REQUEST FOR INFORMATION

PROJECT No. Arapaho Phase III

Arapaho Phase 3 Request For Information Response

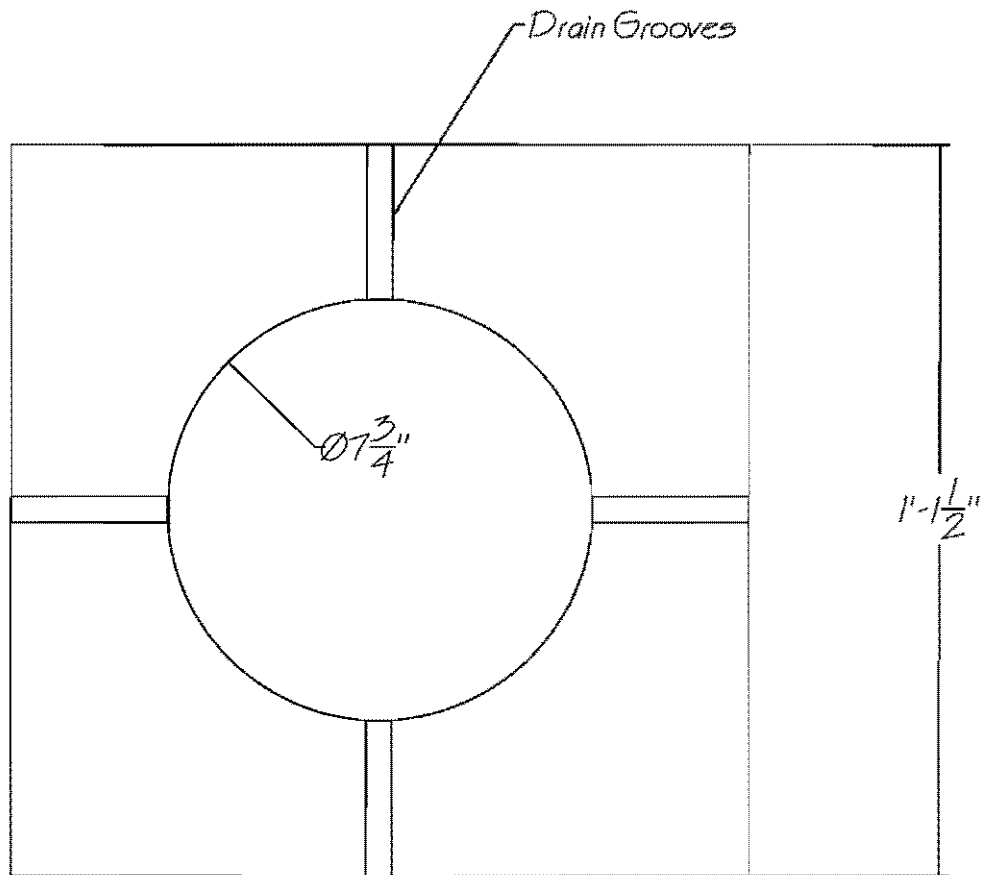
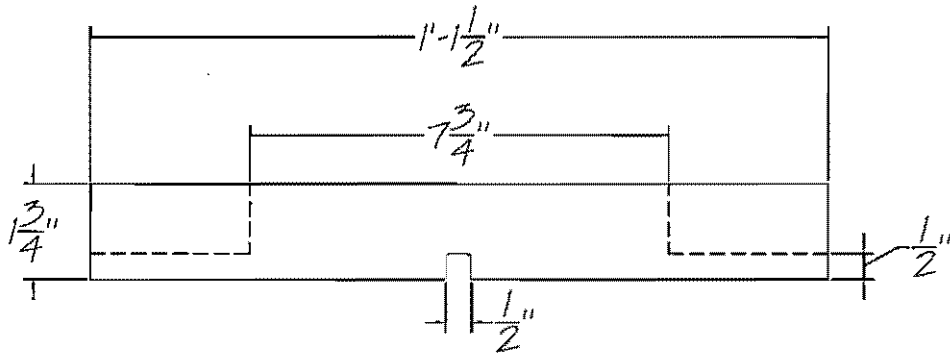
Please review the attached drawing and plan sheet BR-42.

The manufacturer of the cylindrical socket, Clodfelter Bridge and Structures International, Inc. (CBSI), has informed Archer Western that the steel guide pipe detailed on BR-42 is incorrect. The Type 7 anchor socket actual outside diameter is 7 9/16" and CBSI will require an additional 1/4" around the socket for installation.

The attached drawing on the Steel guide pipe and Bearing plate show our proposed changes. The changes are as follow:

1. The pipe was changed to a galvanized 8" schedule 20 pipe, ID 8.125" OD 8.625"
2. The bearing plate was enlarged to 1.12' x 1.12' to compensate for the lose in bearing area from the larger pipe opening.

Please expedite the approve these changes, so that we can proceed with the shop drawings and submittals.

Via email, Richard Beaupre had the following response:

"In response to RFI #11, we agree to the following changes per the latest manufacturers anchorage dimensions (we had contacted the manufacturer during design and we were advised to use a pipe with 7 1/2" ID):

1. The pipe changed to 8" schedule 20 (ASTM A53 - ID 8.125" and OD 8.625").
2. The bearing plate enlarged to 1.125"x1.125" with a 7 3/4" diameter opening.

It was our intention to place the bearing plate prior to casting the diaphragms. The bearing plate should be tack welded to the pipe."

RFI #12

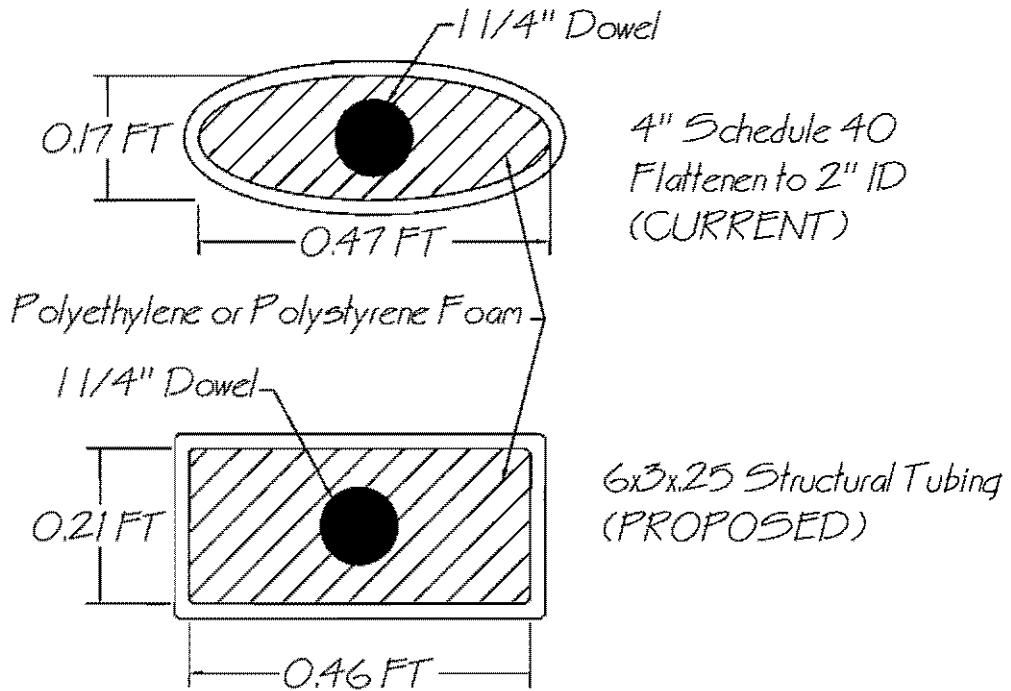
Please review plan sheet BS-9.

Archer Western would like to use a 6x3x1/4 Rectangular Structural Tubing in lieu of the 4" diameter Flattened Steel Pipe, detailed on sheet BS-9.

Please attached Drawing of Current and Proposed Cup

Is this acceptable?

It is preferred that a 5 1/2 X 2 X 3/16 be used. This appears to be a standard shape.
